UNITED STATES PATENT AND TRADEMARK OFFICE

APPLICATION NO.	FILING DATE	FIRST NAMED INVENTOR	ATTORNEY DOCKET NO.	CONFIRMATION NO.
10/049,862	02/19/2002	Max Roth	032553-021	2349
21839	7590	02/23/2006	EXAMINER	
BUCHANAN INGERSOLL PC (INCLUDING BURNS, DOANE, SWECKER & MATHIS) POST OFFICE BOX 1404 ALEXANDRIA, VA 22313-1404			DUONG, THO V	
			ART UNIT	PAPER NUMBER
			3753

Office Action Summary

DETAILED ACTION

FIGURE A: THE MODIFIED FIGURE CORRESPONDES TO FIGURE 4 WITH LIMITATIONS SHOWN

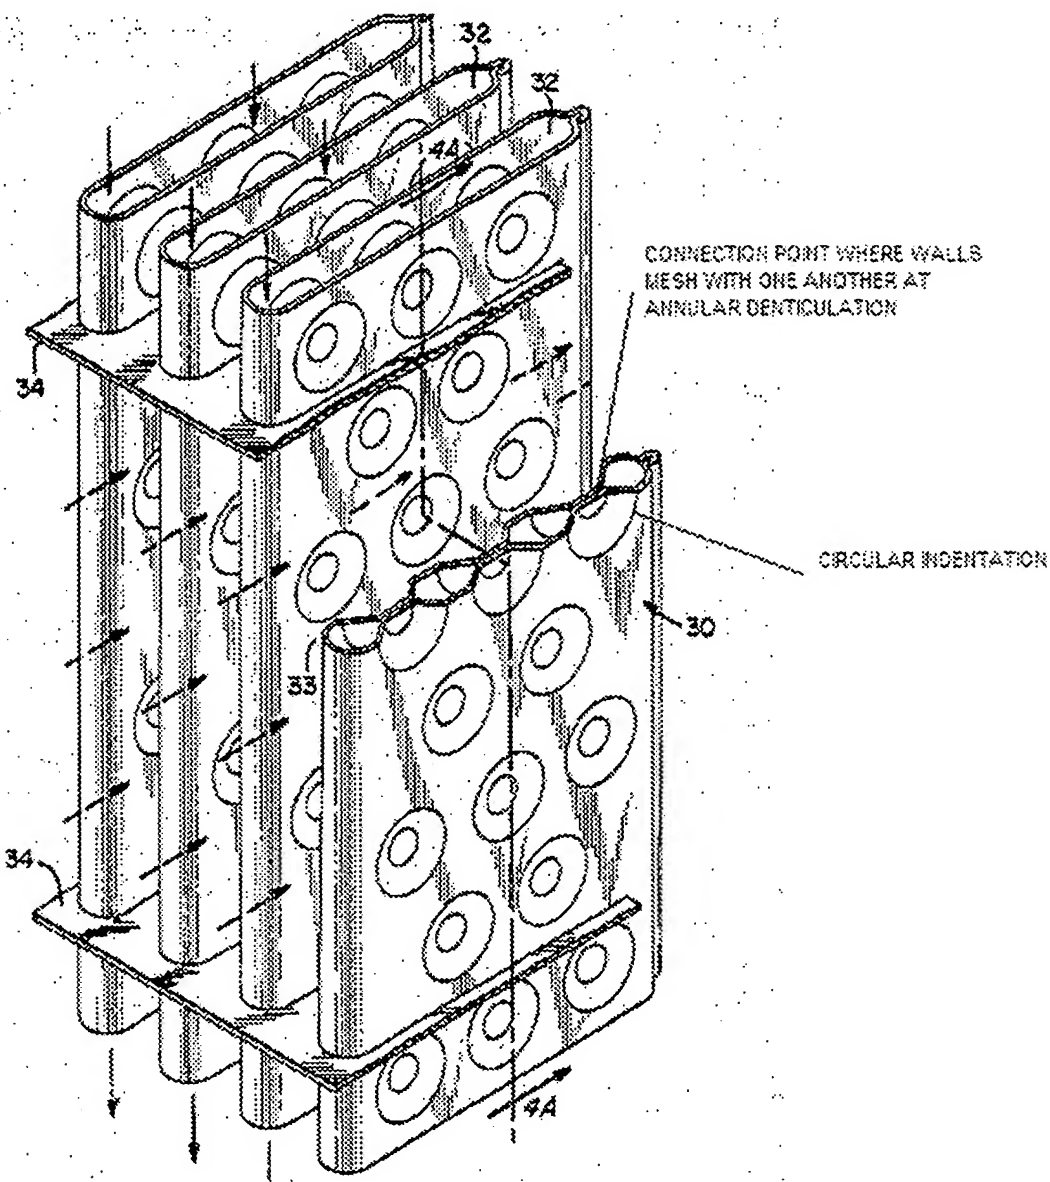
Claims 10-14, 17, 19, 22-23 and 26 are rejected under 35 U.S.C. 102(b) as anticipated by or, in the alternative, under 35 U.S.C. 103(a) as obvious over Kun (US 3,757,855). Kun discloses (figures 2a, 4, 4a and column 6, lines 37-47) a construction kit for a radiator cooling system comprising a plurality of heat exchangers (30); plug connectors (8) for the connection of the heat exchanger; and a tank (10), which is capable of containing hot water. The heat exchanger (21) comprising a two joined together copper walls, which has a thickness of 0.076-6.35 mm, forming a flow through chamber (32) for a heat transfer medium, the walls being joined together at a plurality of connecting points (22) inside a surface between edges of the heat exchanger, wherein the wall mesh with one another at the connecting points (Figure A). Kun further discloses that the annular denticulations are spaced apart at a distance D from 5 mm to 63 mm. The method of forming the device "punctuate fastened", "compression molded annular denticulations" and "are produced by an upsetting-pressing process and without penetration of sheet metal used to form the walls" are not germane to the issue of patentability of the device itself. "[E]ven though product-by-process claims are limited by and defined by the process, determination of patentability is based on the product itself. The patentability of a product does not depend on its method of production. If the product in the product-by-process claim is the same as or obvious from a product of the prior art, the claim is unpatentable even though the prior product was made by a different process." In re Thorpe, 777 F.2d 695, 698, 227 USPQ 964, 966 (Fed. Cir. 1985). In this case, the heat exchanger in the product-by-process claim is the same as or obvious from

the heat exchanger of the Kun, the claim is unpatentable even though the prior heat exchanger was made by a different process.
